**SUBJECT: OYSTER CREEK NUCLEAR GENERATING STATION, - STAFF ASSESSMENT
OF THE RESPONSE TO 10 CFR 50.54(f) INFORMATION REQUEST – FLOOD-
CAUSING MECHANISM REEVALUATION
(CAC NO. MF6111; EPID L-2015-JLD-0013)**

STAFF ASSESSMENT BY THE OFFICE OF NUCLEAR REACTOR REGULATION

OYSTER CREEK NUCLEAR GENERATING STATION

Figure 3.2-1. Site Layout and Topography, Locations of Barriers, and FLO-2D Model Boundary for the Oyster Creek Nuclear Power Reactor Site (modified from Exelon, 2016b, Figure 2).

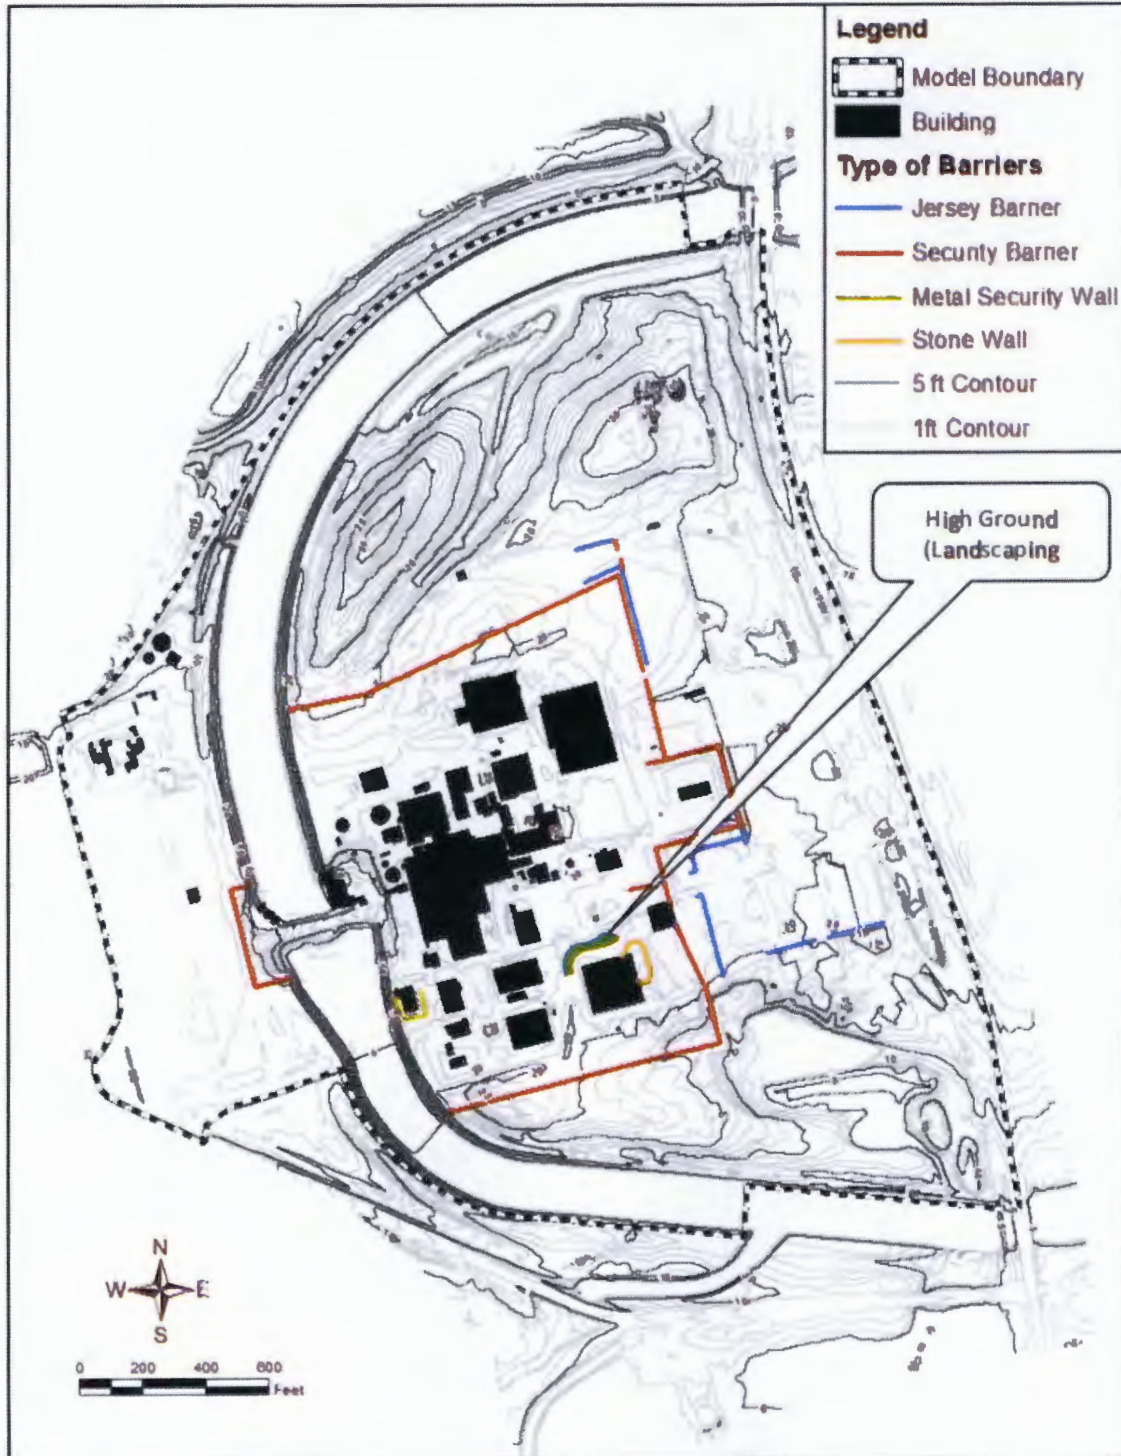
The licensee represented all barriers and other as-built features within the powerblock that could affect flow as levees in the FLO-2D computer model. The licensee assumed the gaps in the security barriers were blocked if they were smaller than 10 ft. the size of the FLO-2D model grid elements. The licensee also assumed a gap in the northeast side of the metal security barrier around the Diesel Generator Building to be open.

The licensee used an outflow boundary around the entirety of the model domain, including the outer bank of the intake and discharge canals (see Figure 3.2-1) (NRC, 2016d). The licensee also assumed that the LIP event did not occur coincident with a river flood (Exelon, 2016b).

Figure 3.2-2. Cumulative Rainfall Depth for the 1-hr, 1mi² PMP at the Oyster Creek Nuclear Power Reactor Site (modified from Exelon, 2016a, Figure 3).

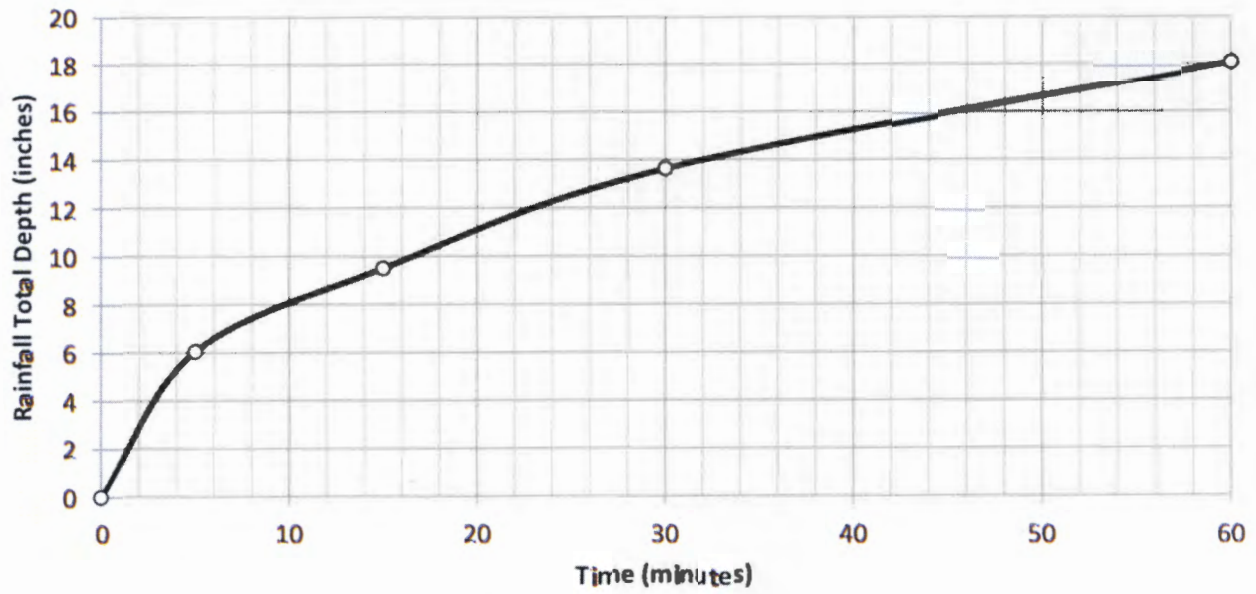
The licensee provided a depth-duration plot for the PMP precipitation, shown in Figure 3.2-2. The licensee applied the most intense precipitation during the initial 5-min increment with the precipitation rate decreasing during successive time increments. The NRC staff verified that the licensee followed the example of NUREG/CR-7046 (NRC, 2011e), Appendix B, and that, given the PMP values, the hyetograph used by the licensee would result in the most rapid rise in water levels at the site.

Figure 3.2-3. Maximum Flood Elevation in the Powerblock Area at the Oyster Creek Nuclear Power Reactor Site Calculated using the Licensee's FLO-2D I/O files. Grid cells with elevations greater than 24.5 ft. represent buildings.

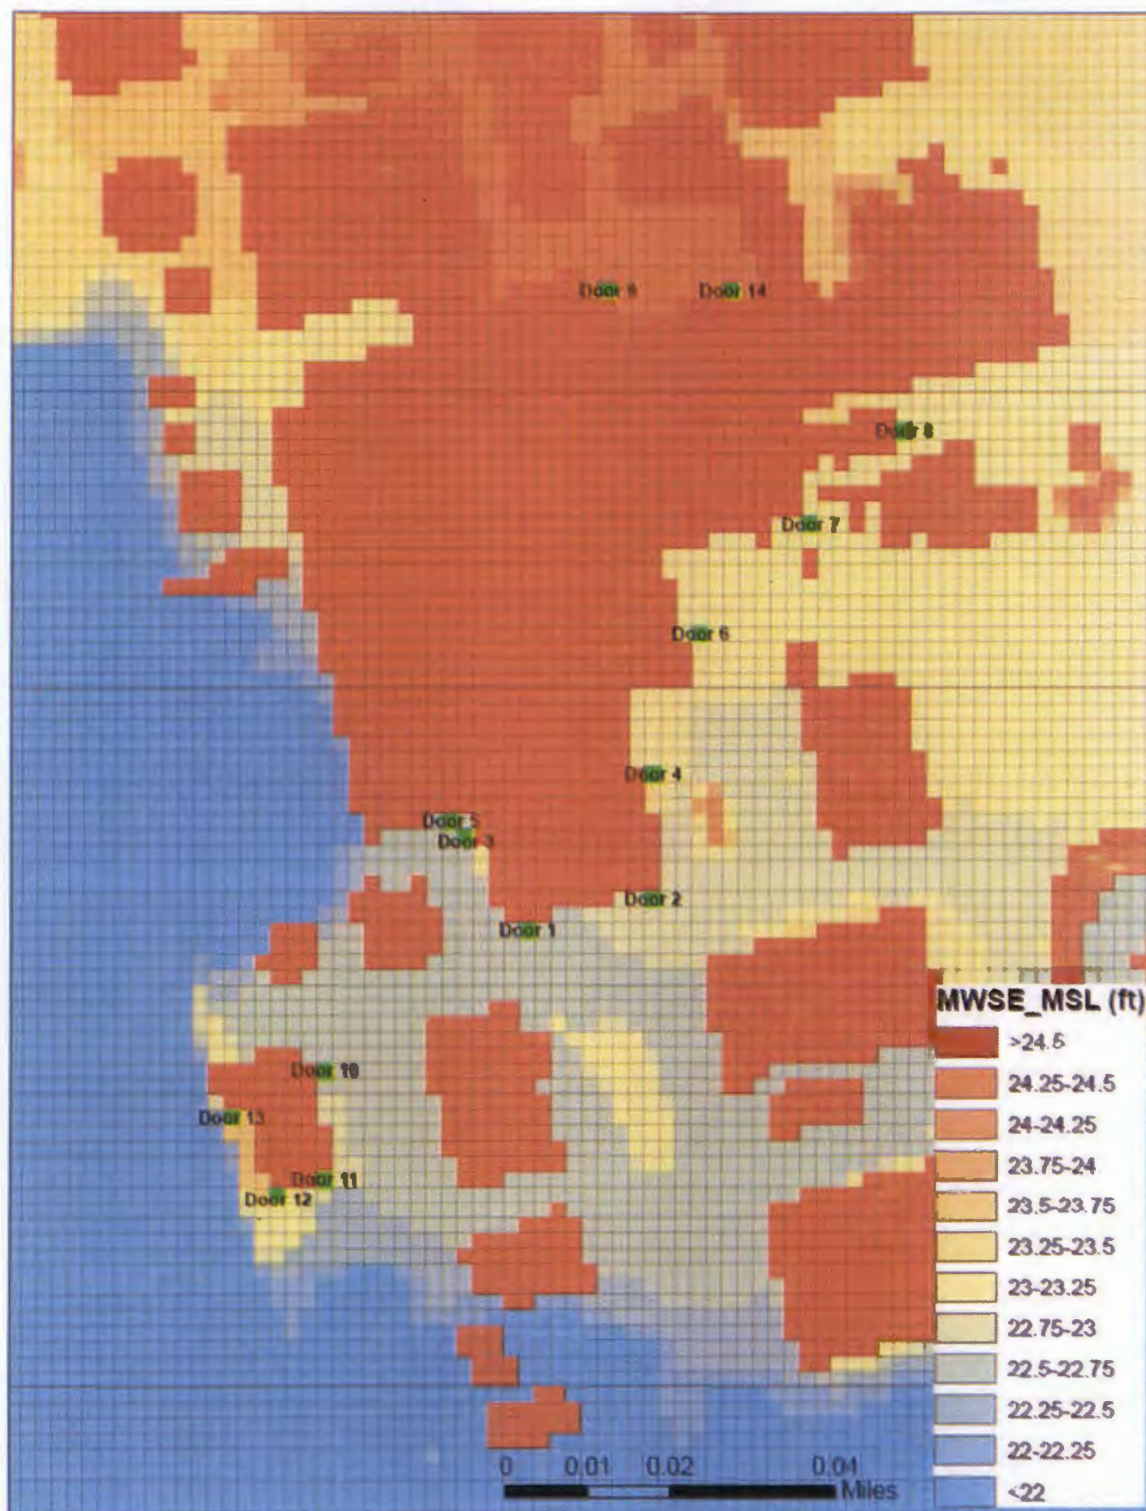
Using the FLO-2D model files provided by the licensee, the NRC staff confirmed the licensee's results described above and in Exelon (2016a). Maximum flood elevations in the power block area, as calculated from the FLO-2D model, are shown in Figure 3.2-3. The NRC staff determined that the licensee's approach was consistent with and supported by the available information, ANSI/ANS (1992), and NUREG/CR-7046 (NRC, 2011e). The NRC staff confirmed the reevaluated flood hazard elevations provided by the licensee.
